SUBJECT: SAFETY RECALL NOTIFICATION

SAFETY RECALL

Sr07-10

DATE : FEBRUARY 2008	SECTION : 07
SUBJECT : ZF-ASTRONIC AUTOMATIC TRANSMISSION GEAR SHIFTER PAD DEFECT

FIGURE 1: H3 COACHES

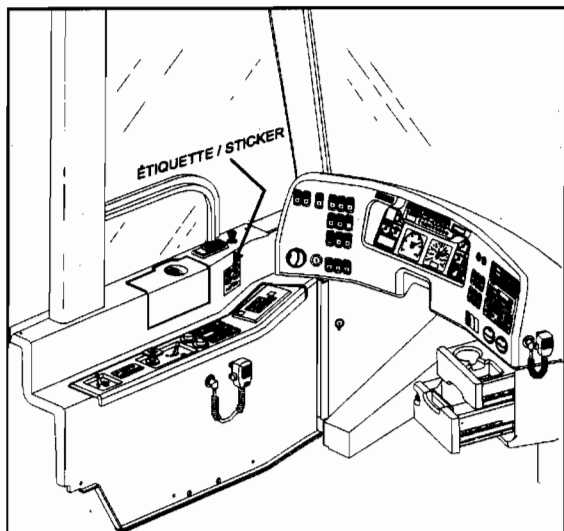
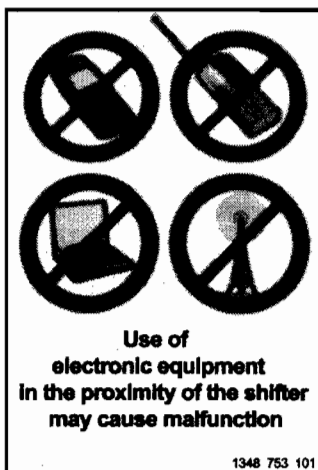
1. Check and confirm that the radio installation is in accordance with the radio supplier's installation guidelines.
2. Affix the sticker onto the L.H. side of the gear shifter pad as per figures 1 and 2.
